FERMI NATIONAL ACCELERATOR LABORATORY
UNITED STATES DEPARTMENT OF ENERGY

LHC 11- TESLA DIPOLE
COIL ASSEMBLY
POLE RE OUTER FNAL

SCALE	DRAWING NUMBER	SHEET	REV
1:1 & AS NOTED	5520.000-MC-482190	1 OF 1	D

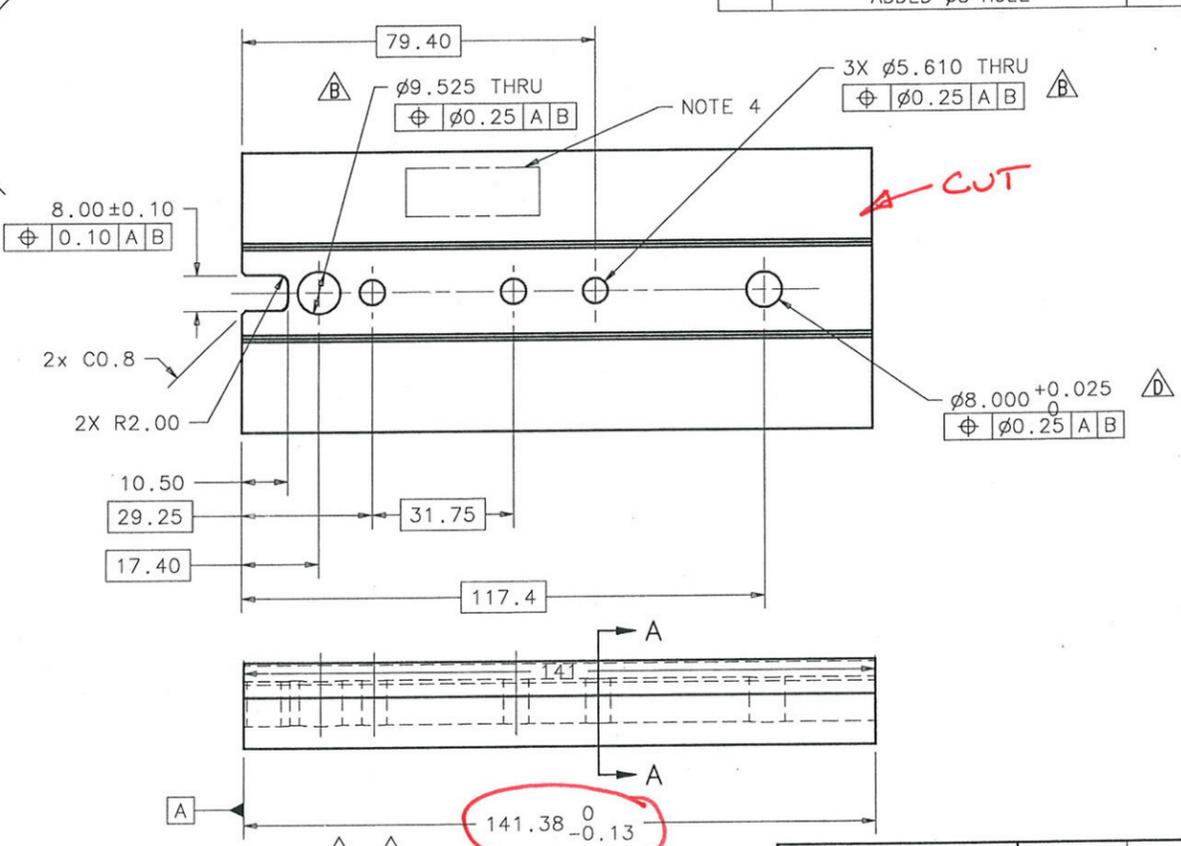
REV	DESCRIPTION	DRAWN	DATE
		APPROVED	DATE
--	ER #9949 NEW RELEASE		
A	ECO# 9979; MATERIAL WAS SS CHANGED TO Ti-6Al-4V GRADE 5	J. COGHILL	14-FEB-2011
B	ECO# 10009; $\phi 5.610$ WAS $\phi 5.110$; $\phi 9.525$ WAS $\phi 8.200$	R. BOSSERT	14-FEB-2011
C	ECO# 10106; 63.24 WAS 63.46; 42.4 WAS 42.63; REDUCED LENGTH ELIMINATED 2 HOLES; REMOVED DIM 21.05; ADDED CHAMFER	J. COGHILL	30-MAR-2011
		F. NOBREGA	06-APR-2011
D	ECO# 10140; 141.38 WAS 87.40 ADDED $\phi 8$ HOLE	J. COGHILL	28-JUL-2011
		F. NOBREGA	08-AUG-2011
